Bulletin #: 2006-002 **Date:** 05/07/06

Subject: Foam replacement on 7-51 rear canopy

7/51 SN 442041 – 442149

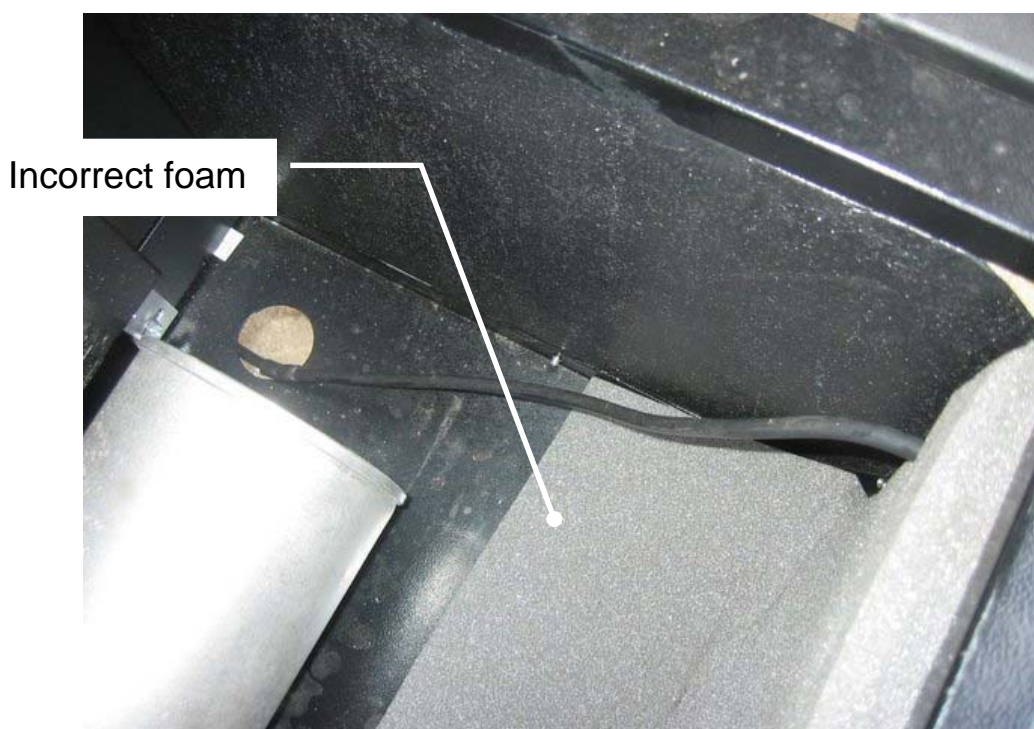
76 machines among the serial number range above have been fitted with not-to-specification insulation foam on the bottom of the fixed canopy. This foam can be recognised easily as it doesn't have a black protection layer on its surface, see photo. As a result dirt can accumulate and this foam will degrade quicker than the correct one.

We recommend replacing the foam with the correct foam panel CPN 54623335. Please advise how many parts you expect to replace in your territory in order for us to estimate the stock required.
